## Building Accessibility Audit Validation Report

895 Eastern Ave. (53,000 sf)

Toronto Fire & EMS Training Centre

Submitted to the City of Toronto  
by IBI Group  
Version 1: May 21, 2021

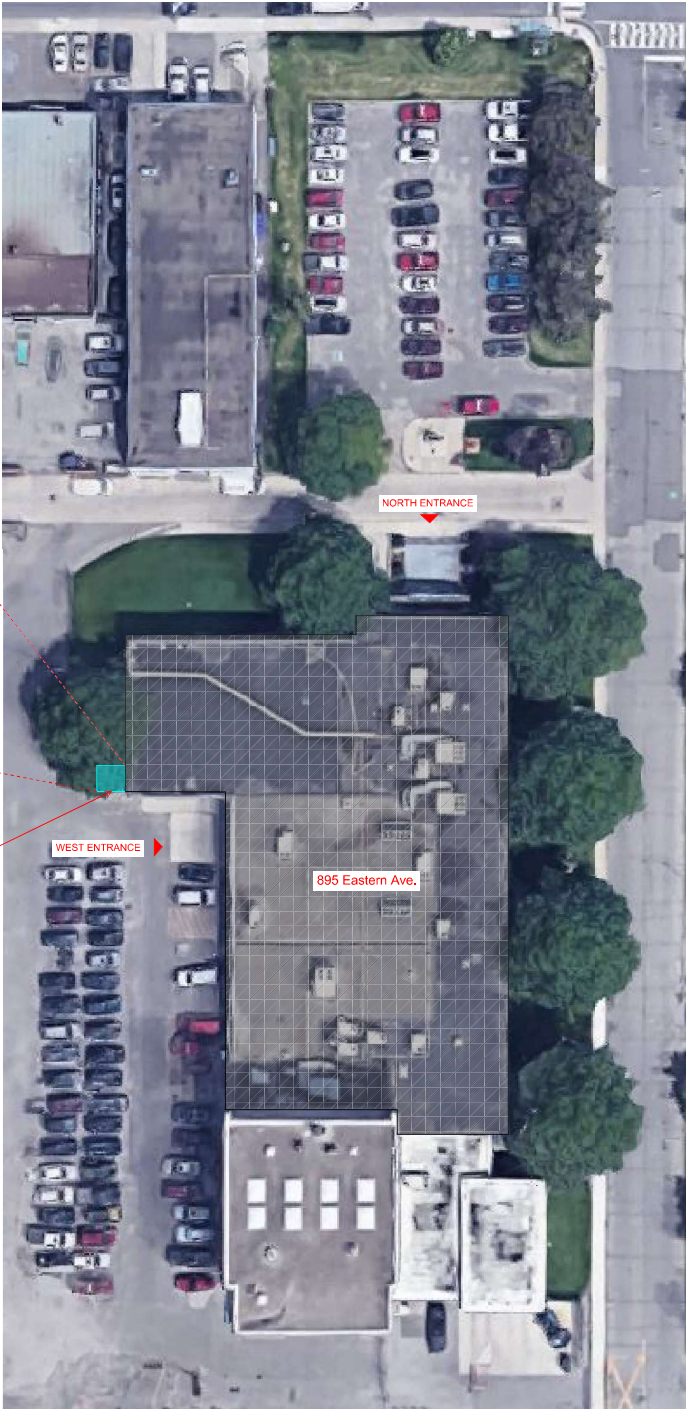
ID 23: Replace existing picnic table and provide 1 TADG compliant picnic table with the required extension with the underside knee and toe clearance.

DRAWN BY: Author	CHECKED BY: Checker	
PROJECT MGR:	APPROVED BY: Approver	
SHEET TITLE <b>GROUND FLOOR - PARTIAL 1</b>		
SHEET NUMBER <b>G14-325-SK.2</b>		ISSUE

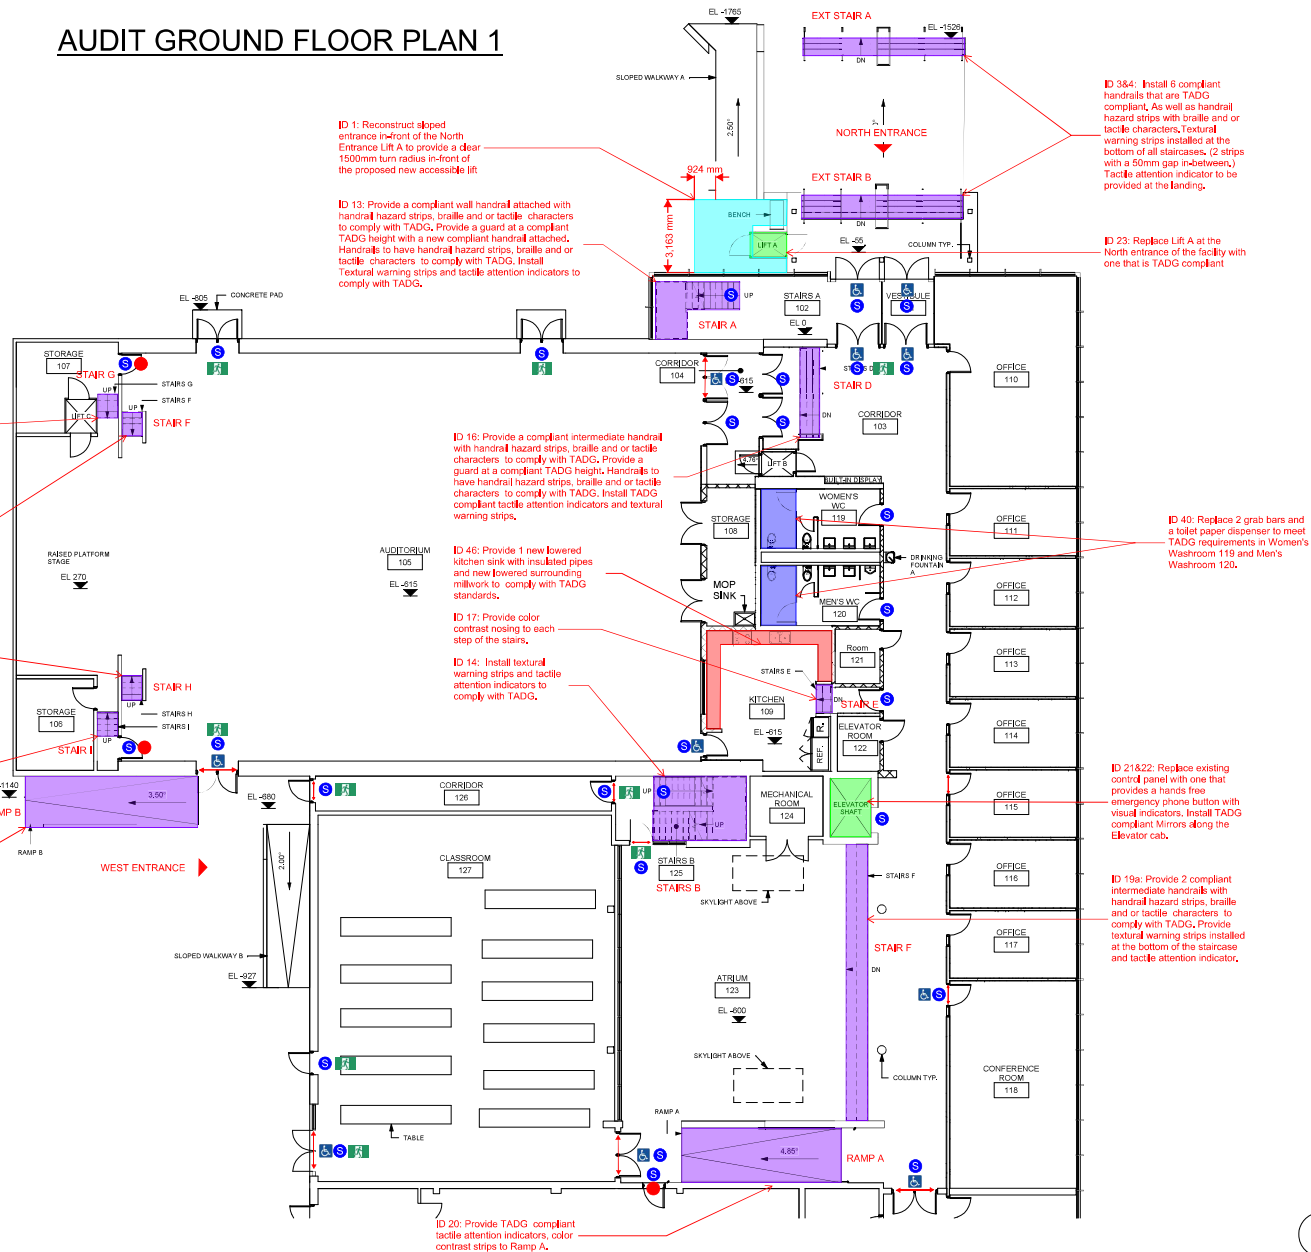
**ID 1: Reconstruct sloped entrance in-front of the North Entrance Lift A to provide a clear 1500mm turn radius in-front of the proposed new accessible lift**

**ID 23: Replace Lift A at the North entrance of the facility with one that is TADG compliant**
